PRODUCT
SUPPORT
BULLETIN # 149

TOOL(S)/PRODUCT(S) AFFECTED: 6850 Swivel Head Shear
6860 Scissors Shear
48-08-0500 Swivel Head Shear Assembly
48-08-0525 Scissors Head Shear Assembly

SUBJECT: Application of Grease to Center Blade/Movable Scissor Blade

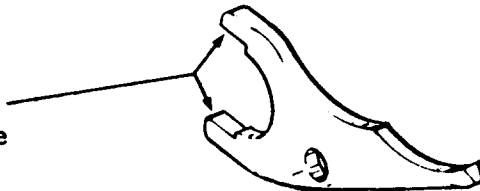
A small amount of Milwaukee Type 'E' grease should be applied to the flats in U-shaped area, (see illustration) of center blade/movable scissor blade, before assembling shear head to gear case.

Lubricate
flats with a dab
of Type 'E' grease
during assembly.
